**REVISED FINAL
Phase I Treatability Study Work Plan
Perchlorate in Groundwater
Baldwin Park Operable Unit
San Gabriel Basin**

**Prepared for
Baldwin Park Operable Unit Steering Committee**

**Revised Final Phase I Treatability Study Work Plan, Perchlorate in Groundwater
Baldwin Park Operable Unit
San Gabriel Basin**

The following are responses to your comments on the Work Plan. Each U.S. EPA comment is repeated below with citation to the page/column/section (e.g. 3/2/2.3) to which you referred. This comment is followed by the BPOUSC response.

PHOTOGRAPH
Typical Contractor GAC/H Pict Unit

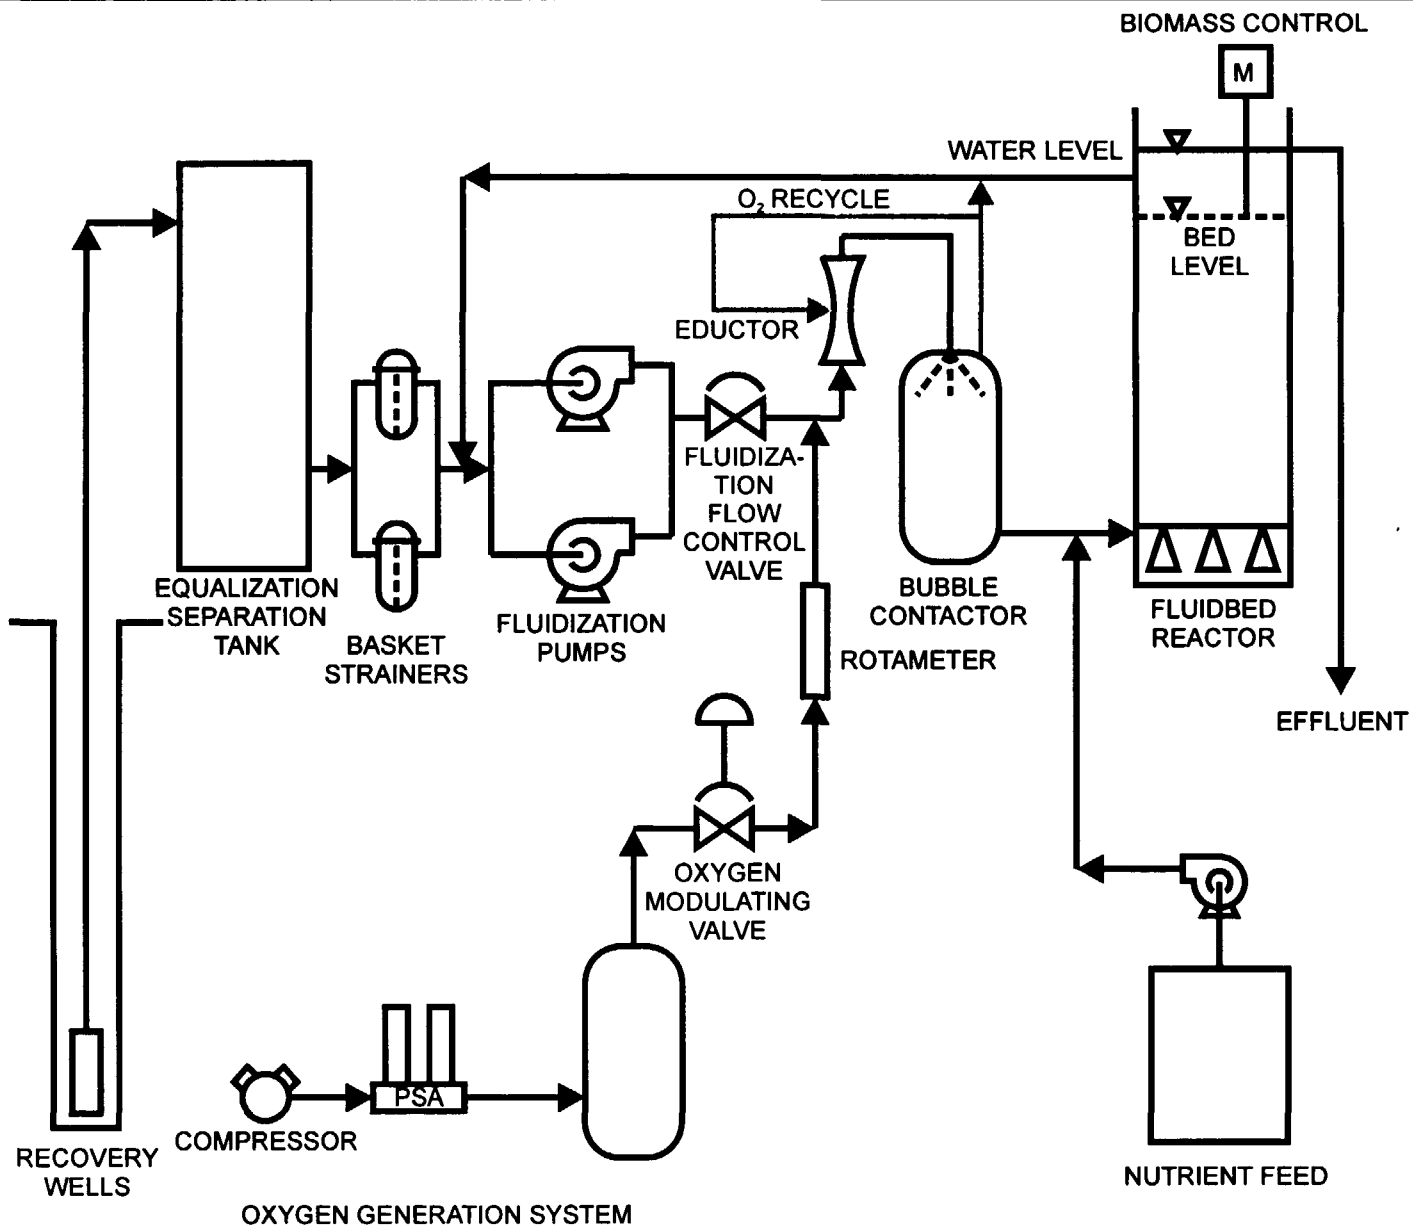
Comment: *The photograph of the pilot unit shows an air compressor, oxygen generator, bubble contactor, and dissolved oxygen control meter. Presumably, these will not be used during the treatability study.*

Response: The photograph of the pilot unit was provided by the vendor. This photograph includes system components that may or may not be used in this pilot study. Specifically the GAC/FB bioreactor will not contain an air compressor, oxygen generator, or bubble contactor. In line meters, placed in the bioreactor influent and effluent lines will measure dissolved oxygen, pH, redox potential, and temperature.

**TYPICAL CONTRACTOR PROCESS AND
INSTRUMENTATION DIAGRAM**

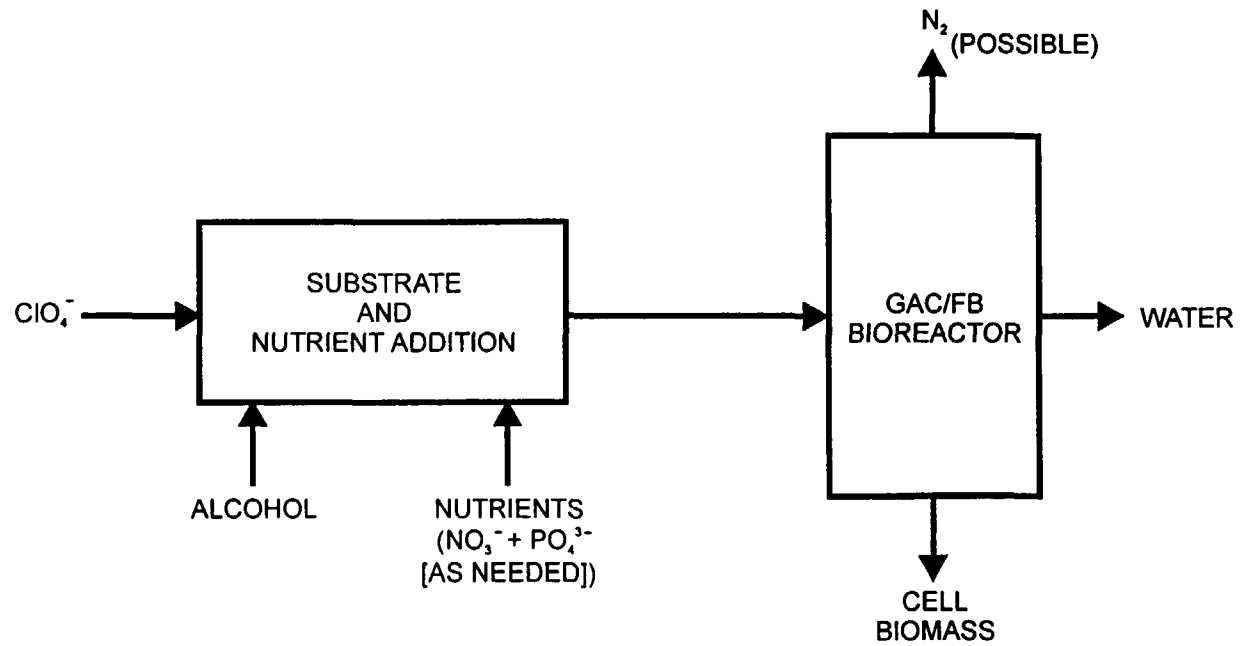
Comment: *The Process and Instrumentation Diagram also shows an Oxygen Generation System and recycling line. Please correct the diagram or explain the need for this equipment. Also, please add other system components described elsewhere in the workplan (e.g., air stripper, filters, effluent pumps, recycle line, backwash line, backwash pumps, effluent equalization tank, 20,000 gallon storage tank, sample ports).*

Please provide a schematic showing the relationship between major system components. Describe the purpose of any components not discussed in the text. If preferred, provide as separate document.

Figure 5-2 shows an equalization separation tank on the influent line. What is the purpose of this tank?

Comment: *The workplan states that DO concentrations in the influent and effluent of the GAC/FB system will be monitored daily. We assume that these measurements will be made at sample ports located on the influent and effluent lines immediately adjacent to the reactor vessel. Please show the locations of the recycle line and sample ports on Figure 5-2.*
11/1/7.1

Project-specific schematic not provided.

Response: The Process and Instrumentation Diagram (P&ID) for the pilot unit is a general P&ID and was provided by the vendor. This P&ID includes system components that may or may not be used in this pilot study.

A schematic showing major system components is not provided in the Work Plan. This request will be addressed by Aerojet in a separate letter.

The 500 gallon effluent equalization tank will be used to assure a constant flow through the pump which sends treated water back to the GET-B system. Contrary to previous discussions, the GAC/FB bioreactor has an internal recycle system and the equalization tank is therefore not needed for this purpose. The text of Section 5.0 has been revised to reflect these changes and provide additional clarification.

Response: The Process and Instrumentation Diagram (P&ID) for the pilot unit, as shown in Figure 5-2, was provided by the vendor. This P&ID includes system components that may or may not be used in this pilot study and does not detail sample port locations. During bioreactor construction sampling valves that withdraw water from the influent and effluent lines will be added and sampling devices that withdraw water from positions that are approximately 25 %, 50 %, and 75 % through the reactor flow path will be added.

A project specific schematic is not provided in the Work Plan. This request will be addressed by Aerojet in a separate letter.
